SERVICE BULLETIN

TITLE: Inspection of Stabilizer Leading Edge
Attachment

BULLETIN NO. 254

MODELS AFFECTED: 108 (Voyager and Flying Station
Wagon). Serial 108-1 through 108-
3500, Inclusive

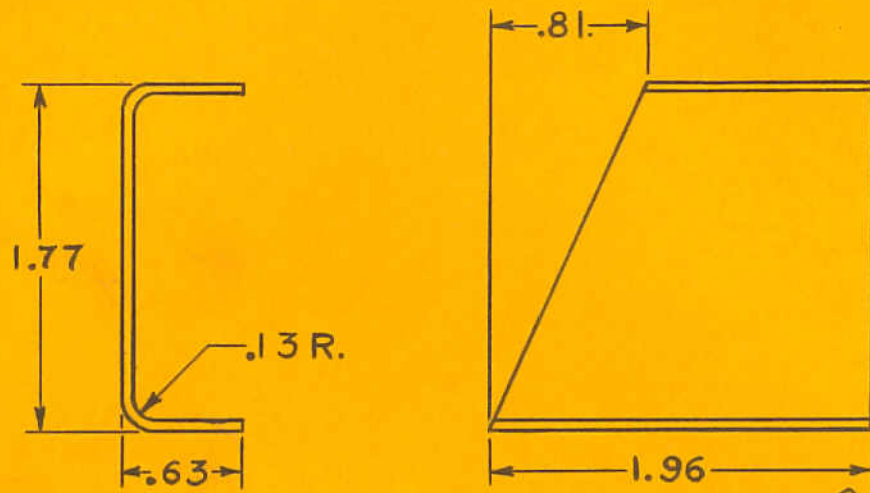
To determine whether or not fatigue cracks have developed in the fitting that attaches the horizontal stabilizer to the fin, it is recommended that all airplanes in the above category be inspected at this point. It is further recommended that this inspection be made after each 100 hours of operation.

If fatigue cracks have developed, the following corrective action should be performed:

1. Remove the horizontal stabilizer forward attaching bolts and drop the leading edge to insure accessibility.
2. Drill a 1/16" stop-hole at each end of the crack to prevent spreading.
3. Fabricate and attach reinforcing channel to the stabilizer fitting as shown in the following sketch.

Locate two rivets
through web to clear
crack

PARTS REQUIRED:

1 Piece 24ST Aluminum Sheet - .040 - 2" x 3"
7 - AN442-AD5 Rivets

NOTE: If cracks are found in both fittings, it will be necessary to fabricate and install two reinforcement plates and in those instances we will make a labor allowance of 3.0 hours.
